ME6818 Adoption of NFPA-805 by Duane Arnold Energy Center (DAEC)

Initial Questions Developed at Second Audit of DAEC

Conducted on May 30-31, 2012

Figure 1. Model for Fire Propagation in a Cable Tray Stack
(Figure R-5 from NUREG 6850)

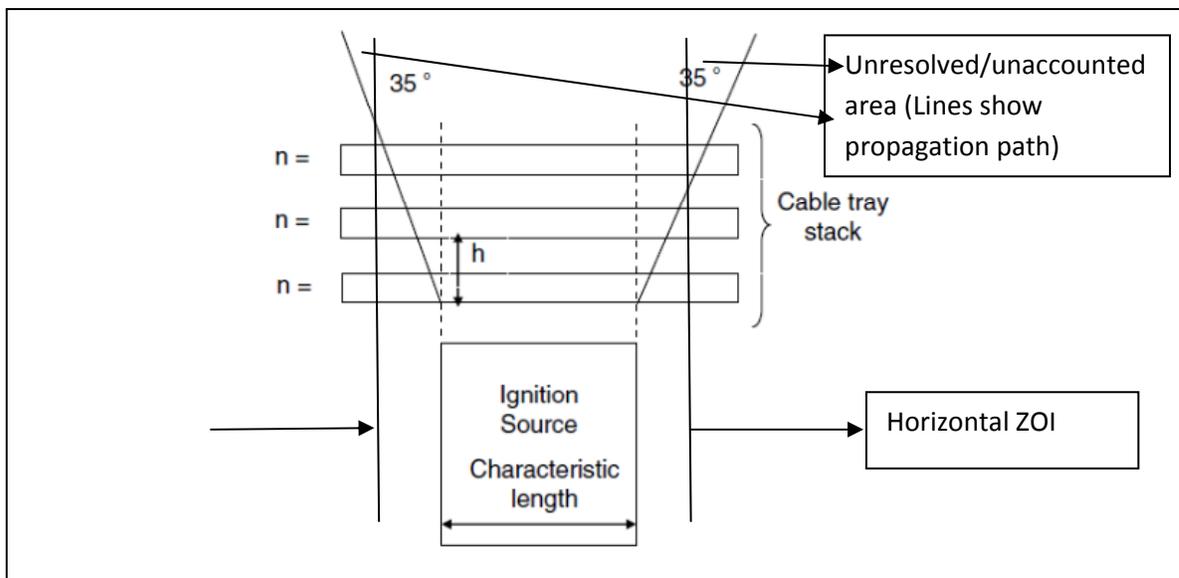
5. Generic Treatments Review: It was discussed at the audit that it is assumed that the secondary combustibles in the cable trays do not affect the applied ZOI. According to NUREG-6850, Section R.4.2, fire will spread at an angle of 35 degrees (see Figure 1 below). It is not clear what happens to the area that is included in the 35 degree sector, but not included in the rectangular ZOI. The staff requests that the licensee provide additional justification for not using the method described in Section R.4.2 of NUREG 6850.
